Submission on Rotokauri Strategic Infrastructure Designation Notice of Requirement, Hamilton City Council

1.0 Introduction

Figure 6: Stormwater Drawings [Appendix B.3].

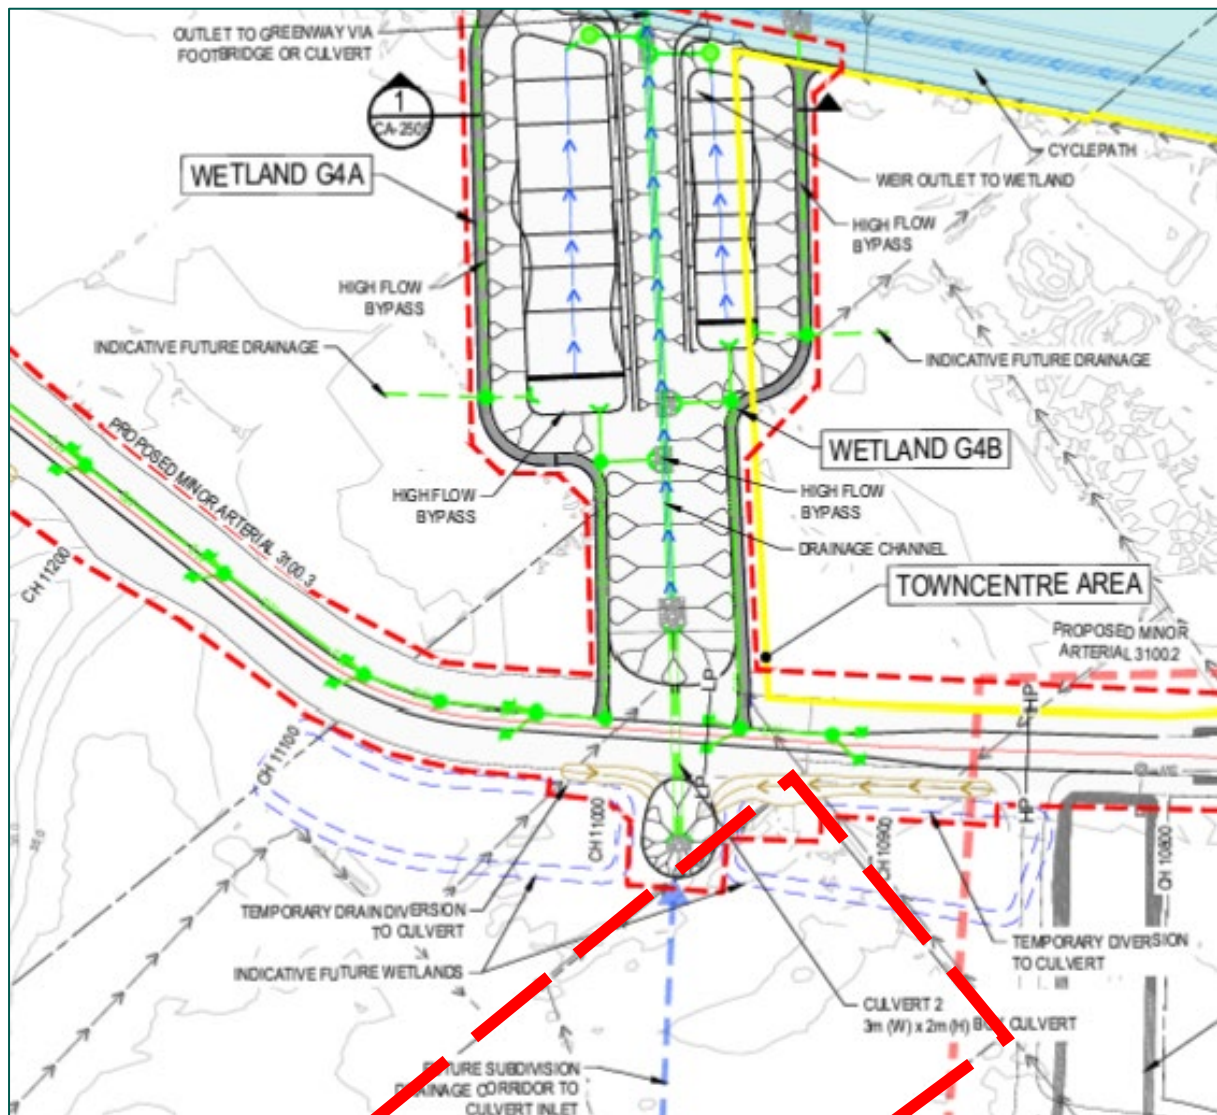
As shown in **Figure 6**, “indicative future wetlands” are shown on the property, which are not included within the designation footprint. Section 5.6 of the Design Report [Appendix D in the NOR documentation] states, *“Only wetlands that receive runoff from the proposed roads will be included within the proposed designation. This leaves several wetlands identified in the Greenway NoR and ICMP documents to be designed and developed in the future as part of adjacent subdivision developments. These other wetlands are indicatively shown on the drawings to show the wider stormwater management context.”*.

Pragma seek flexibility in relation to the “indicative future wetlands” particularly their location, sizing and design. They straddle several property boundaries, which is unrealistic and undeliverable.

Initially, the relief sought is the removal of these “indicative future wetlands” from the NOR drawings.

Otherwise, Pragma seek that all “indicative future wetlands” are labelled with the statement: “Any indicative future wetlands are an indicative option for providing stormwater storage outside of the constructed Greenway. Each land owner will determine, design and consent the actual design, location and size of any additional stormwater storage device related to their property.”

Figure 7: Roading Drawings [Appendix B.2].

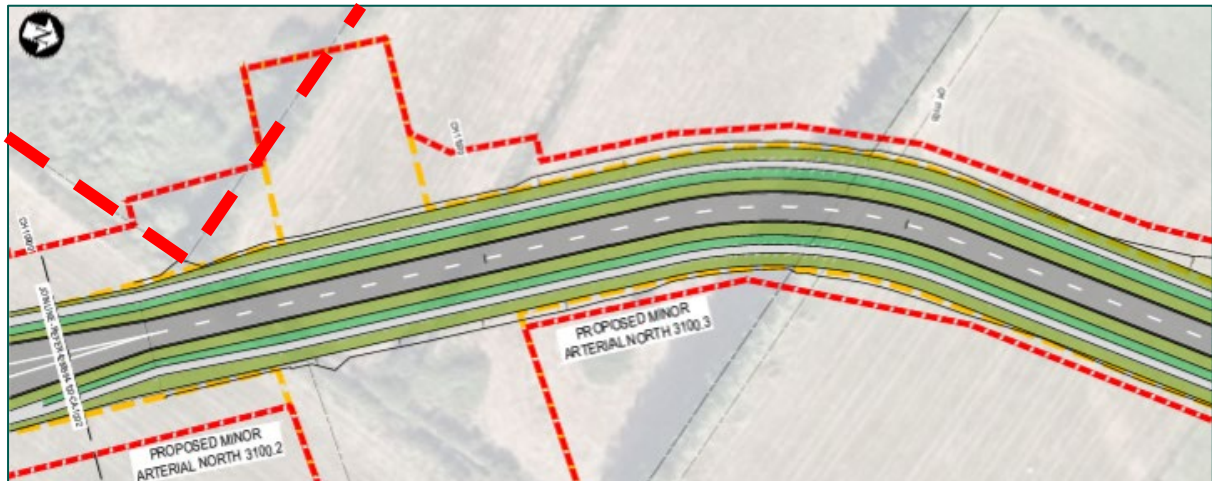
The low point in the Minor Arterial transport corridor will determine the secondary overland flow spill point (and 100-year ARI flood levels) for the upstream/western development areas. The level of the Minor Arterial transport corridor will set what land within a development needs to be lifted to provide freeboard to the 100-year ARI flood level.

The Roding Drawings [Appendix B.2 in the NOR documentation] shows a low point in the transport corridor at approximately RL33.50 metres. This means low lying areas of the property will be below this level and will require filling to lift the connecting transport corridors to the Minor Arterial transport corridor and building platforms above the spill point.

Hence, it is critical that the vertical alignment of the Minor Arterial transport corridor carefully considers the secondary overland flow paths and the effect on upstream development land. The existing sag in the vertical alignment in the vicinity of Culvert 2 should be kept as low as possible to limit the required fill to lift the property above the low point.

Pragma seeks circulation of the design pack to provide feedback and ensure efficiency and integration with their proposal for the property. Further, it is requested that the vertical alignment of the Minor Arterial transport corridor be designed to the lowest practicable level.
